UV REPLACEMENT AT HAVERSTRAW ELEMENTARY SCHOOL

MSA File No. 41048

NOTICE TO BIDDERS

Re: ADDENDUM NO. 3

UNIT VENTILATOR SCHEDULE

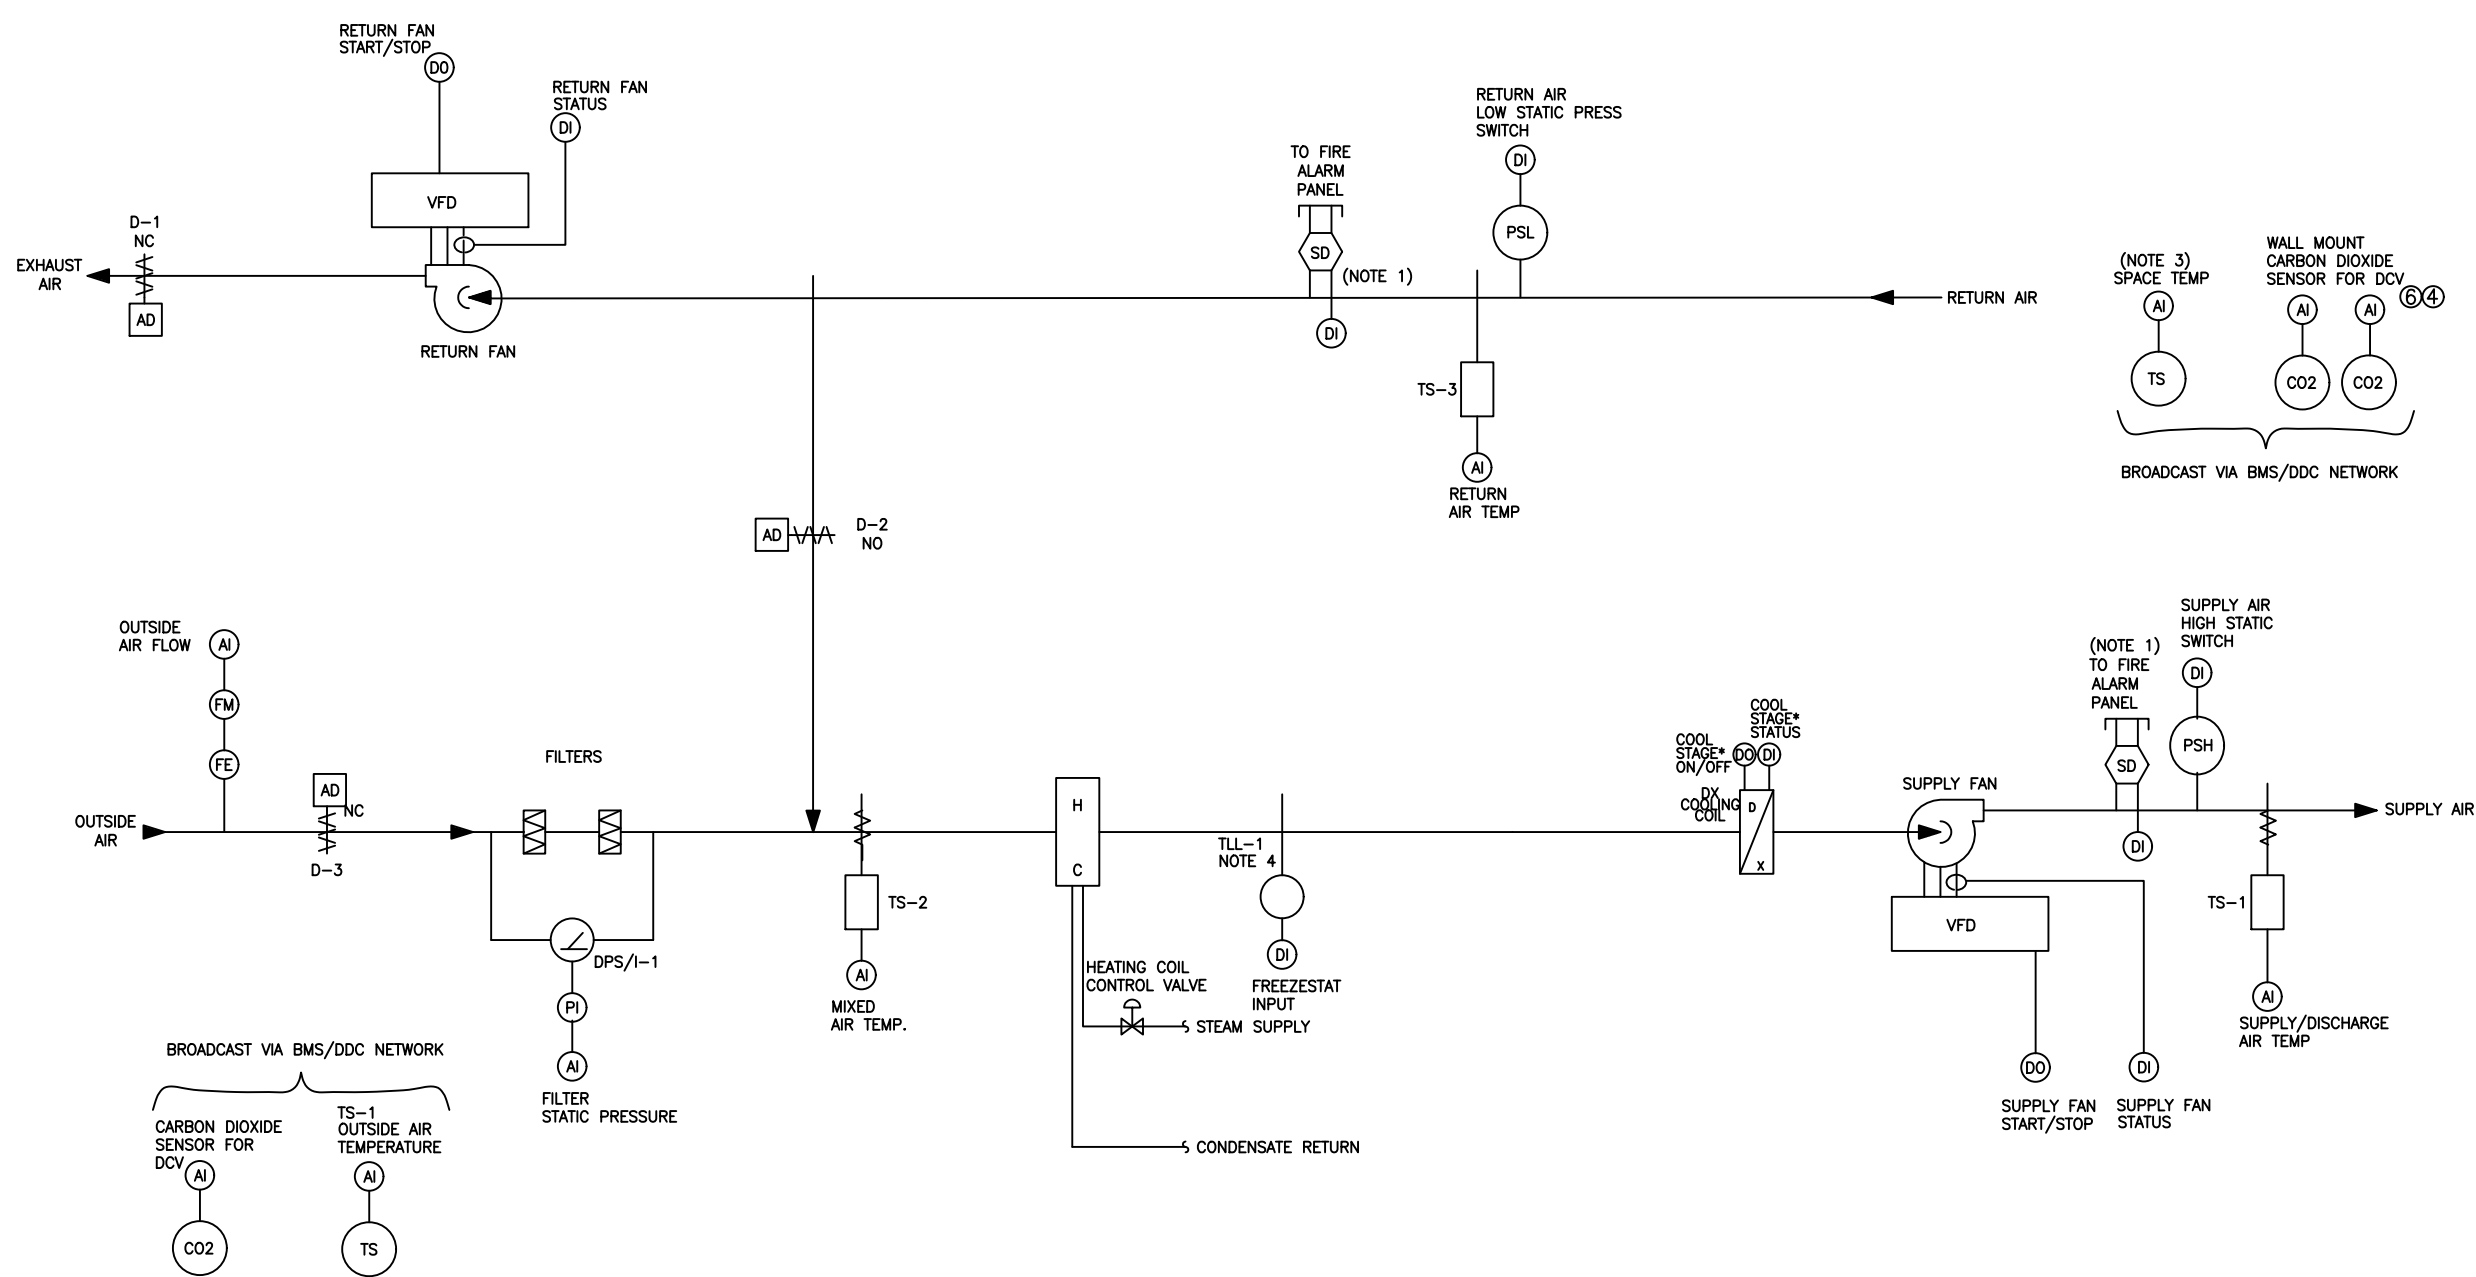
4. M-004- Clarified valve indication on detail 2, to indicate STM(Steam) valve.
5. M-006- Added notes regarding controls for Unit Ventilators. Added note regarding to shop controller separate for field installation due to global chip shortage crisis and long lead time

HVAC DEMO - 1ST FLOOR PLAN

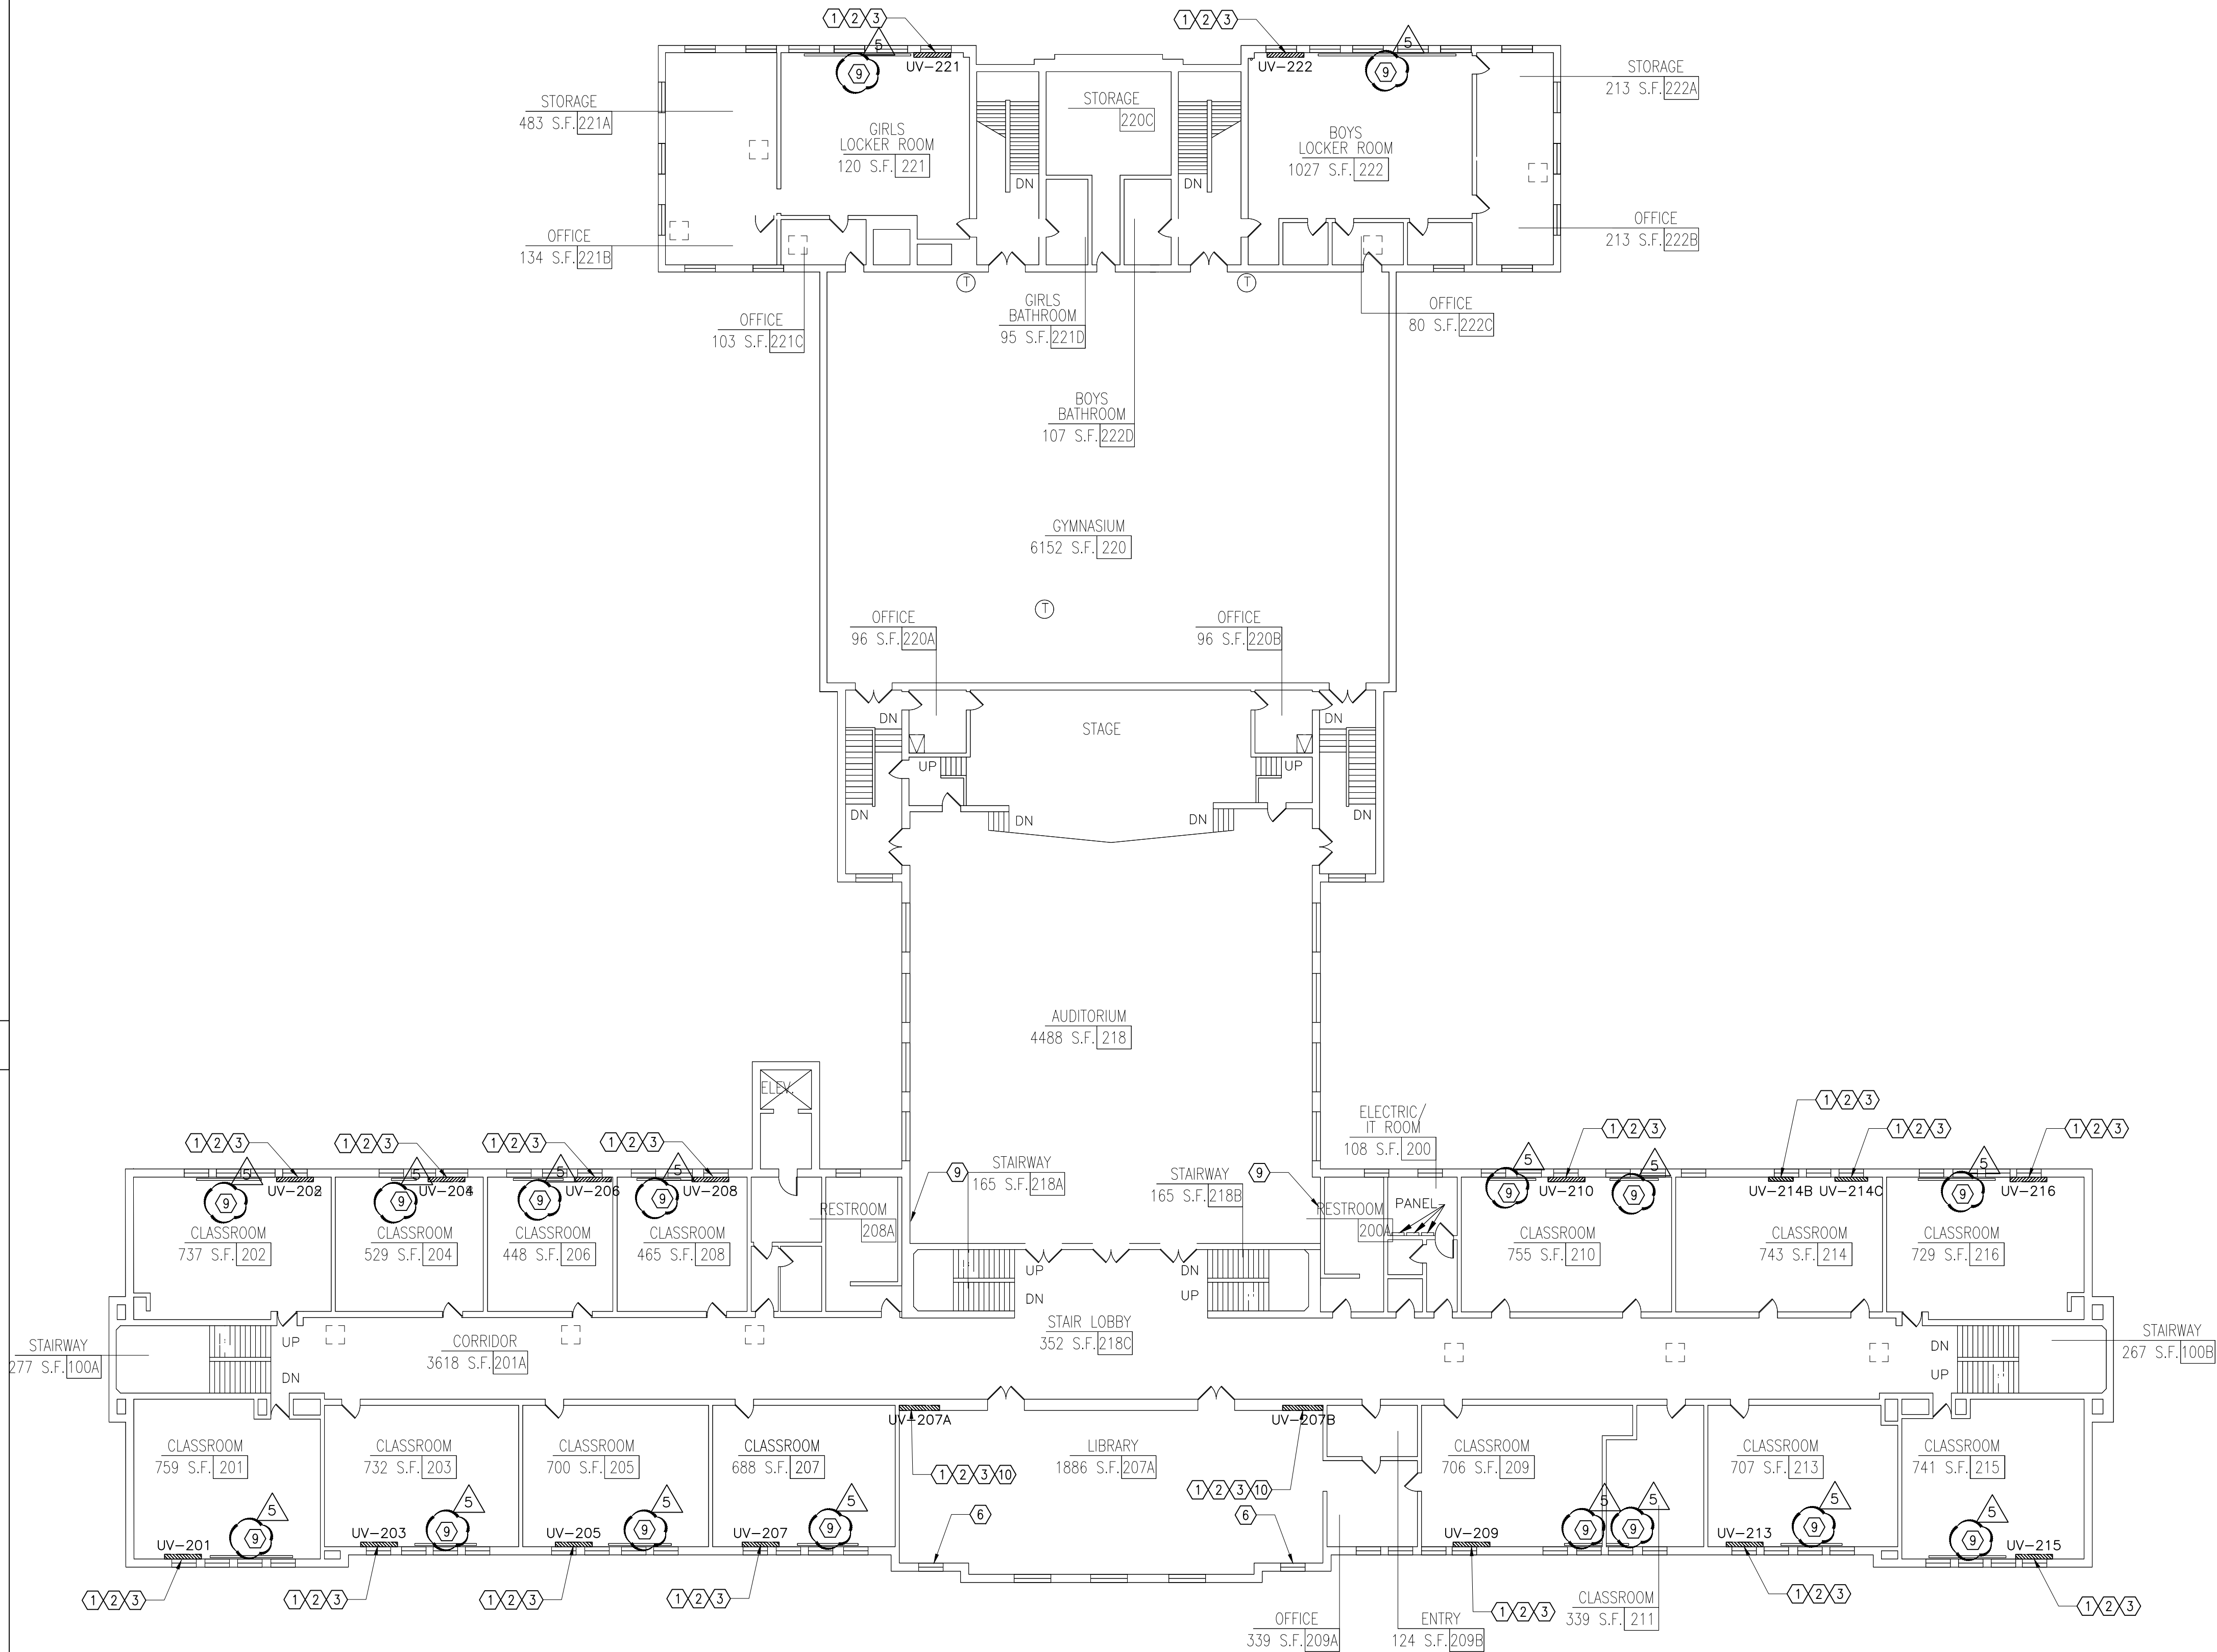
6. M-061- Added “-Demo” to title of part plan. Added room names throughout for clarity purposes.
7. M-062- Added “-Demo” to title of part plan, added keynote #9 throughout part plan to indicate areas where radiators are to remain.

Drawing Title
**1ST FLOOR
 PLAN -
 MECHANICAL**

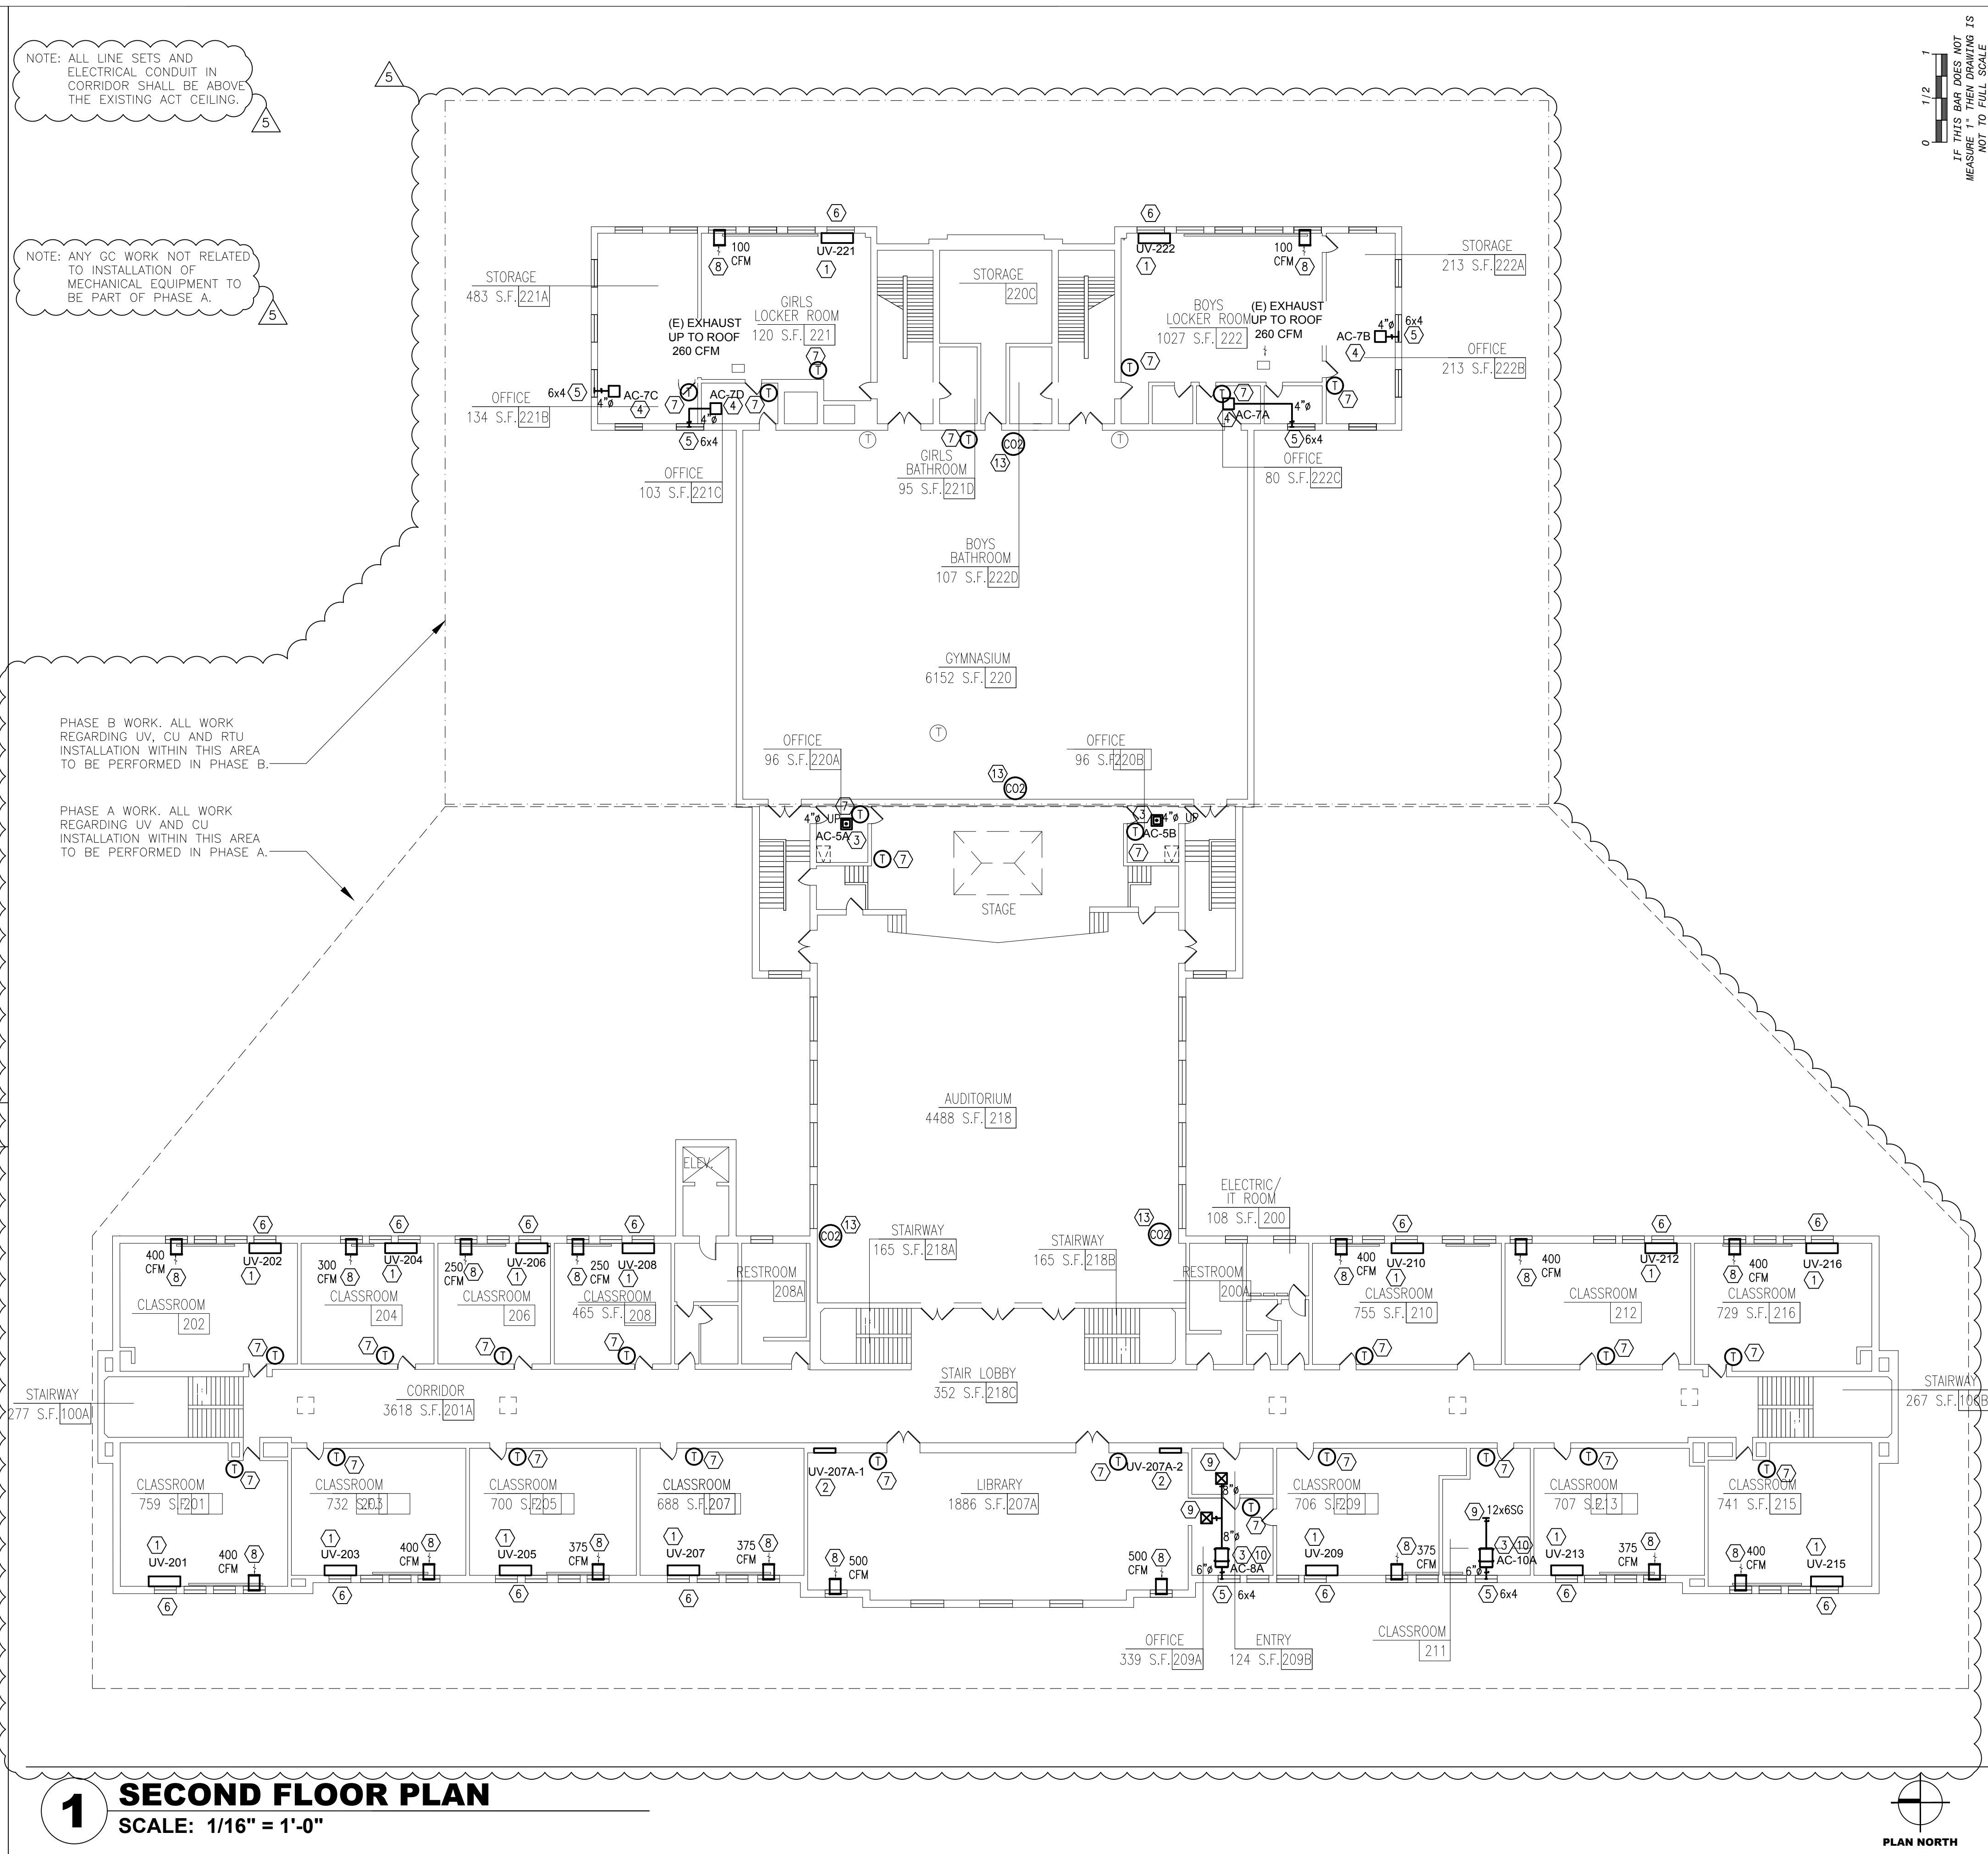
- 2) Clarification for location of unit CU-5. Refer to note 13 on M-101. The unit is to be wall mounted outside on the first floor level but 3’-0” above grade.

8. M-063- Added “-Demo” to title of part plan, added keynote #9 throughout part plan to indicate areas where radiators are to remain.
9. M-101- Added phasing and phasing notes, revised keynote #9 to indicate side grille type product, approved equal Titus 300/350 added.

- (13) FURNISH AND INSTALL NEW OUTDOOR CONDENSING UNIT, SEE SCHEDULE ON DRAWING M-002. MOUNT AND SECURE UNIT TO WALL. UNIT SHALL BE MOUNTED MIN. 3'-0" ABOVE GRADE.
